City of Phoenix

Staff Report: Z-124-23-1

Single-family residential

Location:

SITE
PLAN

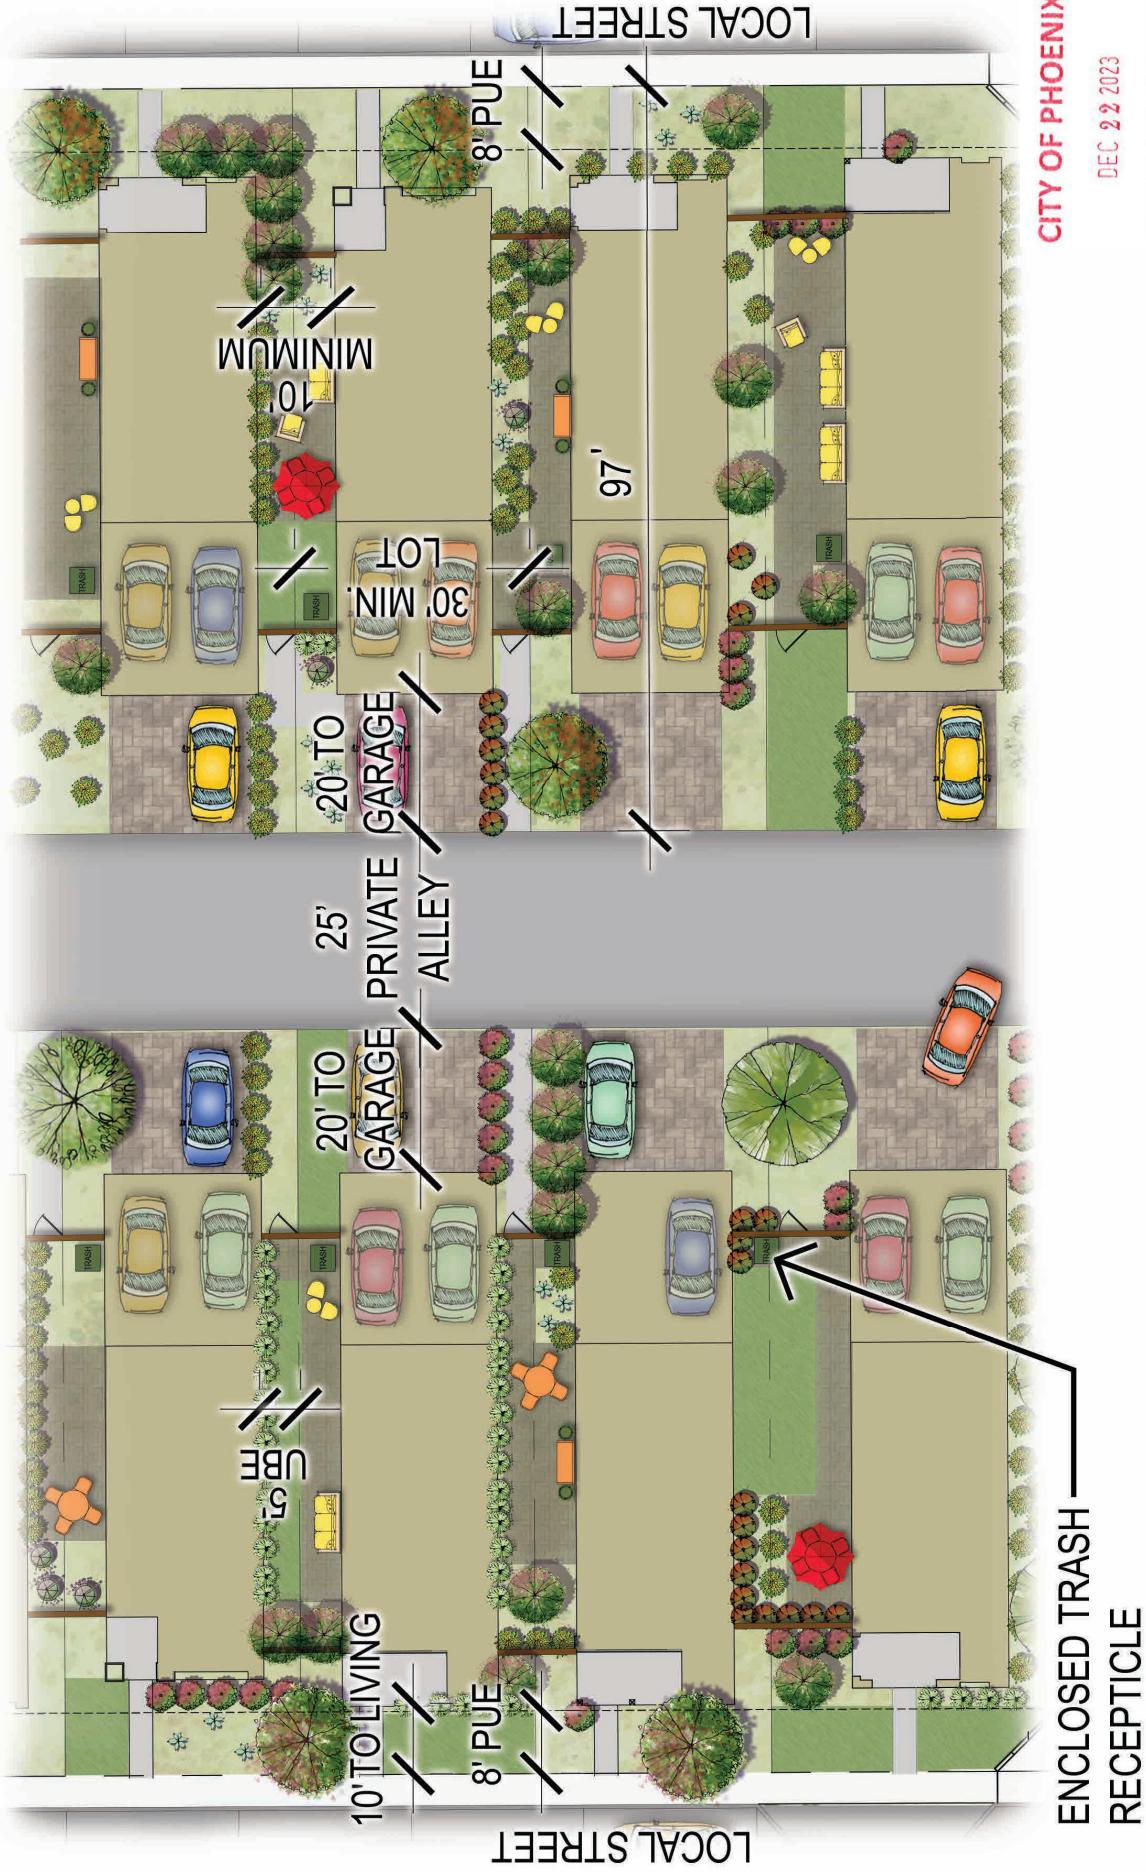
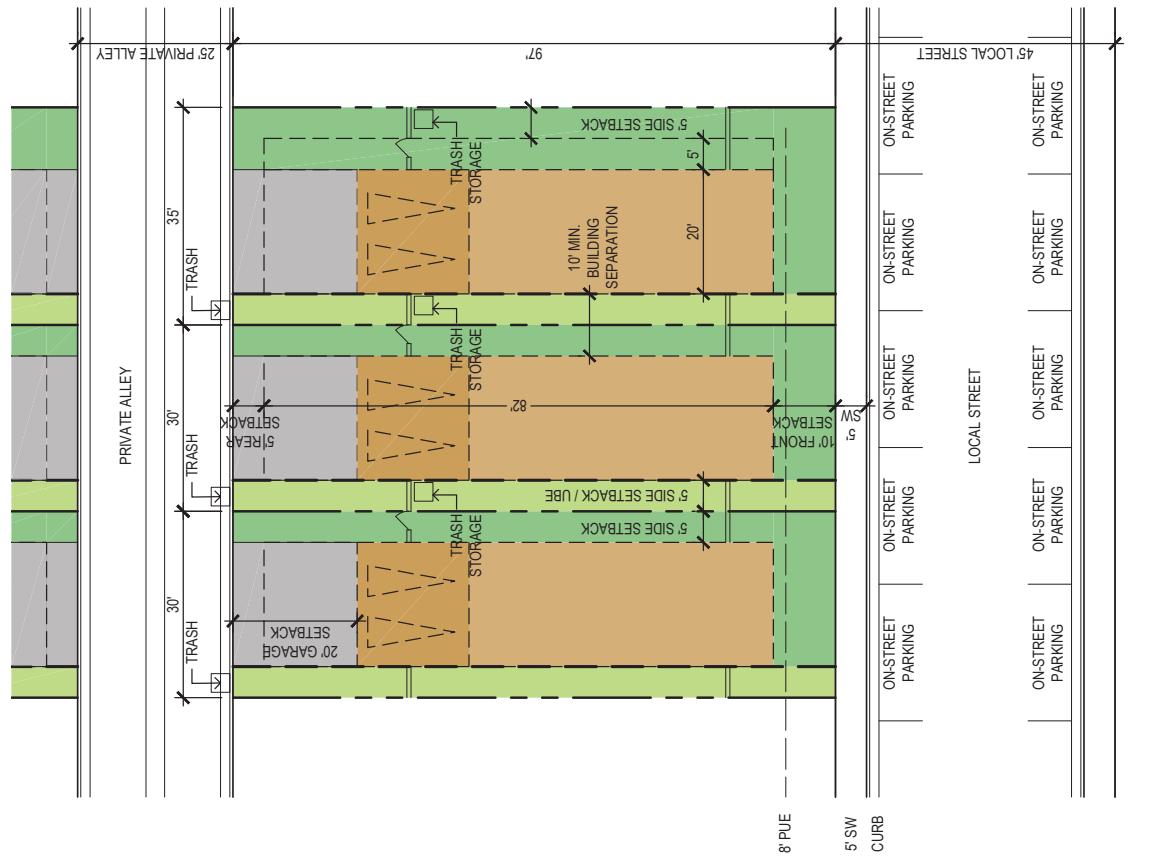
The site plan, attached as an exhibit, proposes a 72-lot single-family residential development. The proposal includes typical lots ranging from 30 feet wide to 35 feet wide by 97 feet in depth, 28 percent of open space dispersed throughout three retention areas, a multi-use trail along the western perimeter of the site, a north-south pedestrian connection along the eastern perimeter of the site, and 29 16-foot-wide private accessways used solely for rear garage loading with the front sides of the homes proposed to face either a local street or a pedestrian walkway. Since the current design includes private accessways without sidewalks, dead-end private accessways, and garage-dominated private accessways, also referred to as private streets, it is not in compliance with various Subdivision Ordinance and Zoning Ordinance requirements and would require requesting technical appeals and variances; therefore, staff does not recommend stipulating general conformance to the site plan.

In order to ensure the density does not exceed the proposal of 72 units, and to ensure the residential density does not exceed the General Plan Land Use Map designation of 3.5 to 5 dwelling units per acre, staff recommends the maximum

In order to enhance compatibility with the surrounding area, which is primarily open space, staff recommends a minimum of 10 percent of common open space be provided, which is double of the minimum common open space required by the Zoning Ordinance. This is addressed in Stipulation No. 2.

To further pedestrian safety, and to provide scenic views, staff recommends that where walls are provided and are longer than 55 feet, a combination of view walls/fencing and partial view walls/fencing (with minimum two feet of view fence atop the wall) shall be incorporated along property lines adjacent to dedicated public or private open space areas, natural and/or improved drainageways or recreational areas, except where adjacent to a perimeter street. This is addressed in Stipulation No. 20.

1. The maximum density shall be 5.04 dwelling units per gross acre.

2. A minimum of 10% of common open space shall be provided, and shall be evenly dispersed throughout the development, as approved by the Planning and Development Department.

PLAN 2016 A - SCHEME CS1A
Spanish Colonial

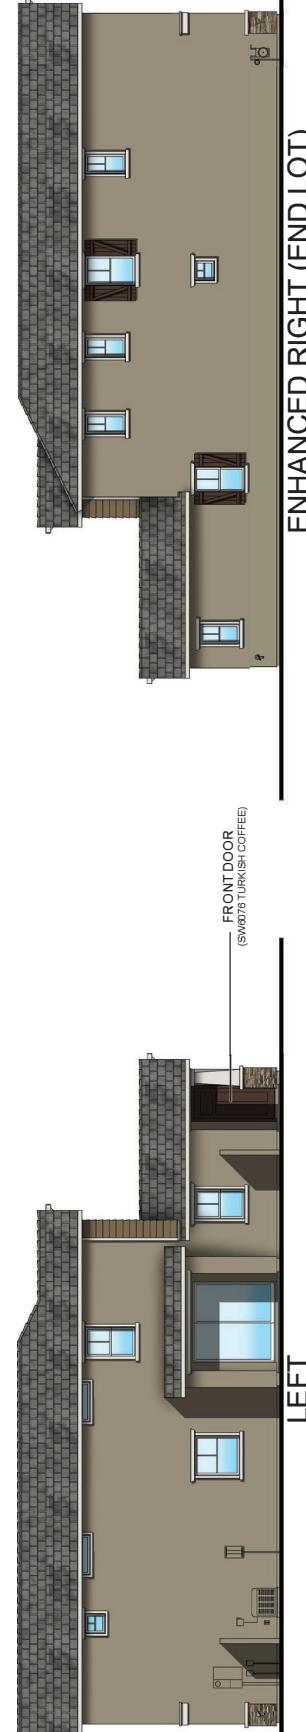
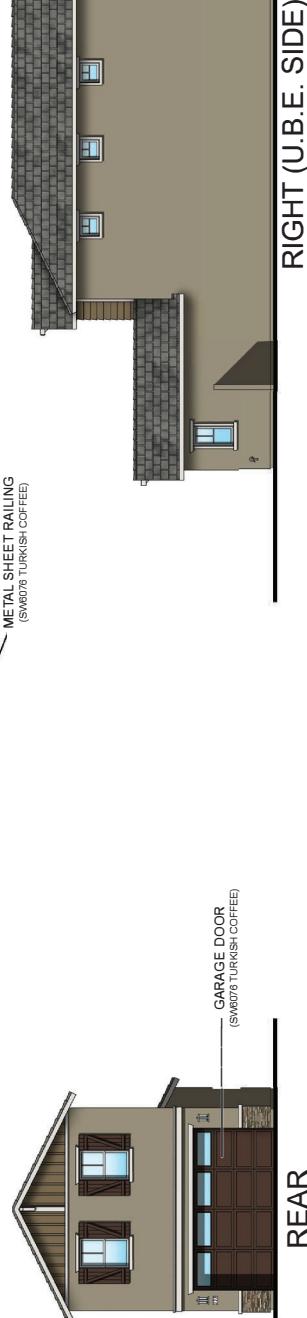
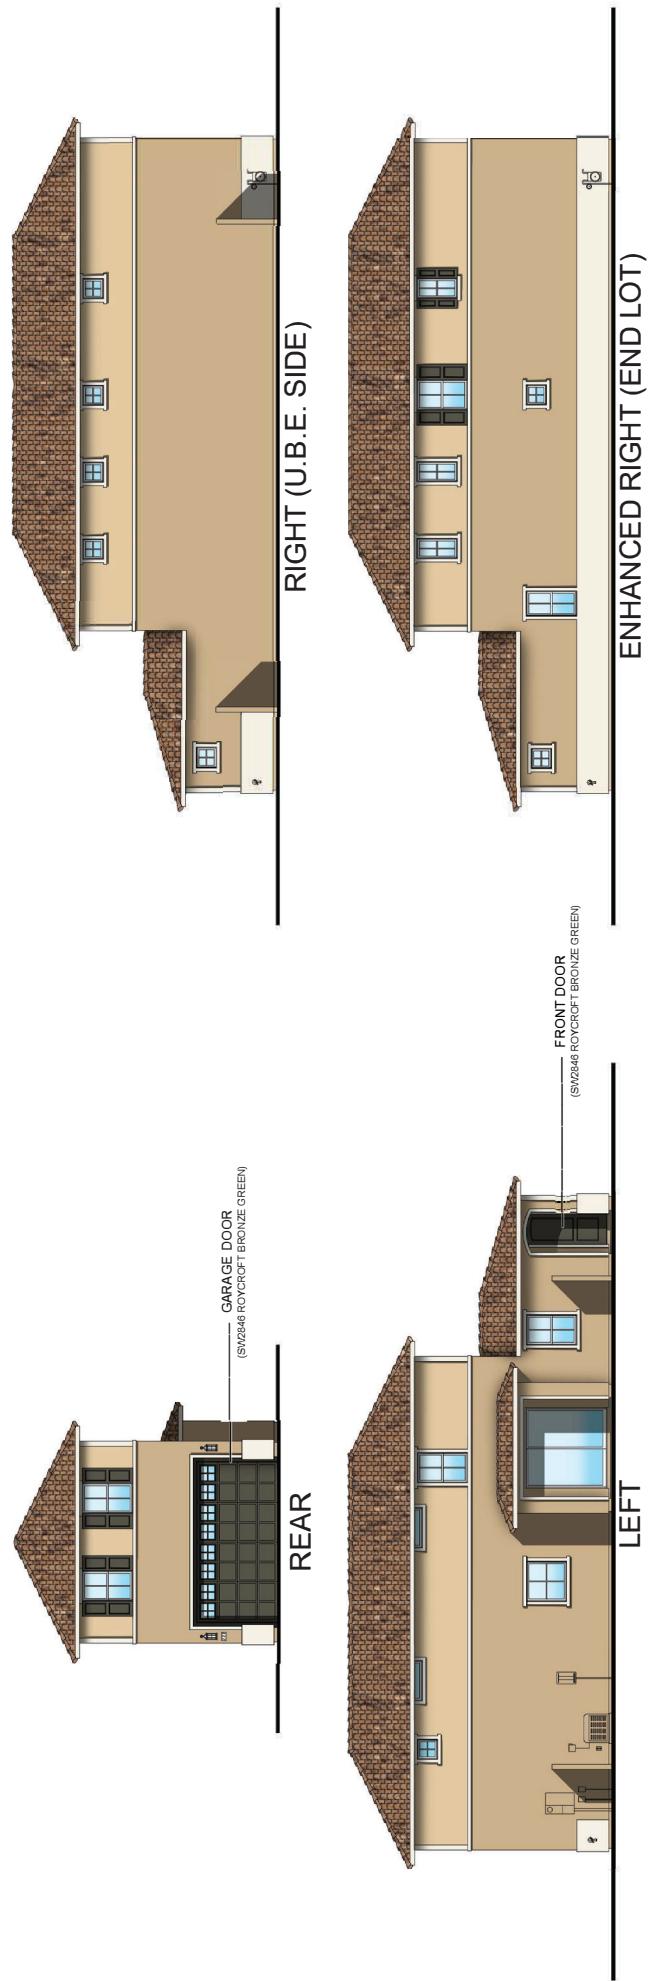
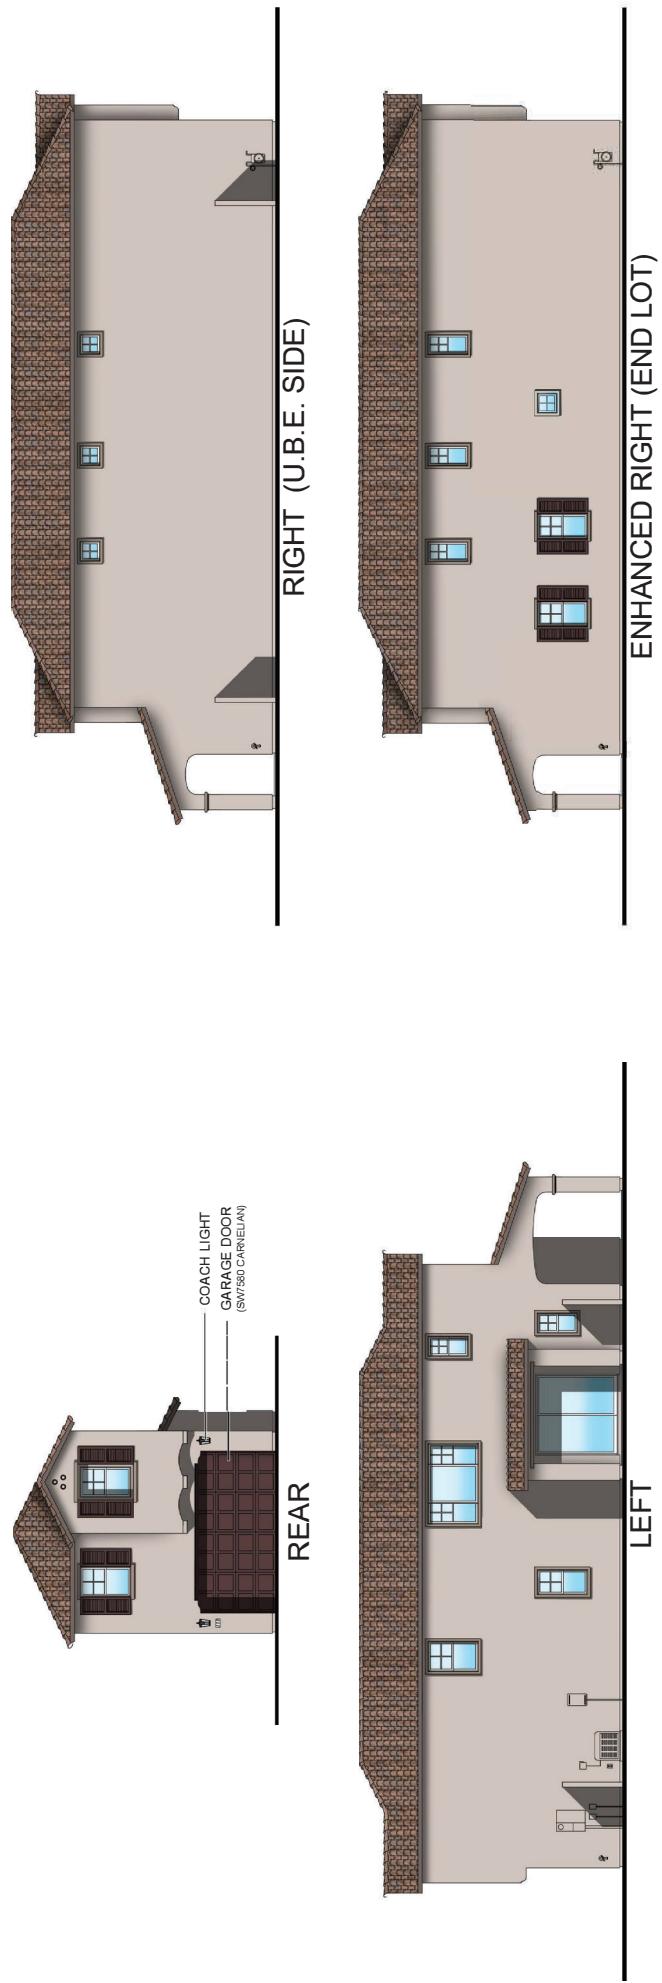
The elevations, attached as an exhibit, propose a variety of architectural styles and include plans for two-story single-family residences with a variety of colors, materials, breaking of massing, window and glass door muntins and mullions, window and door treatments, architectural embellishments, gable end treatment, front covered porches, window shutters, and decorative lighting fixtures.

However, due to the garage width being more than 50 percent of the home width along the proposed private accessways, the elevations would require a variance to allow the garage width with the current proposed design; therefore, staff does not recommend stipulating general conformance to the elevations.

- That materials and colors blend with the natural desert environment.
- That enhanced building materials and four-sided architecture be provided.
- That a minimum of nine varying elevations be provided.
- That a minimum of five architectural styles be provided.
- That a minimum of six of the elevations include a front covered porch measuring a minimum of 6 feet deep x 12 feet and 7 inches wide.
- That a maximum of three of the elevations may include a covered entry with a minimum width of 2 feet and 6 inches
- That enhanced decorative windows be used on all front sides of homes.
- That elevations have varying rooflines of the homes.
- That all garage doors have windows and recessed panels.

3. The building elevations for single-family residential development shall comply with the following standards, and if multifamily residential development occurs it shall comply with a and b below, as approved by the Planning and Development Department.

- a. Materials and colors shall blend with the natural desert environment.
 - b. Enhanced building materials and four-sided architecture shall be provided.

- c. A minimum of nine varying elevations shall be provided.
 - d. A minimum of five architectural styles shall be provided.
 - e. A minimum of six of the elevations shall include a front covered porch measuring a minimum of 6 feet deep by 12 feet and 7 inches wide.

- f. A maximum of three of the elevations may include a covered entry with a minimum width of 2 feet and 6 inches.
 - g. Enhanced decorative windows shall be used on all front sides of homes.

- h. Elevations shall have varying rooflines of the homes.
 - i. All garage doors shall have windows and recessed panels.
4. A minimum building setback of 58 feet shall be provided along the west property line, as approved by the Planning and Development Department.
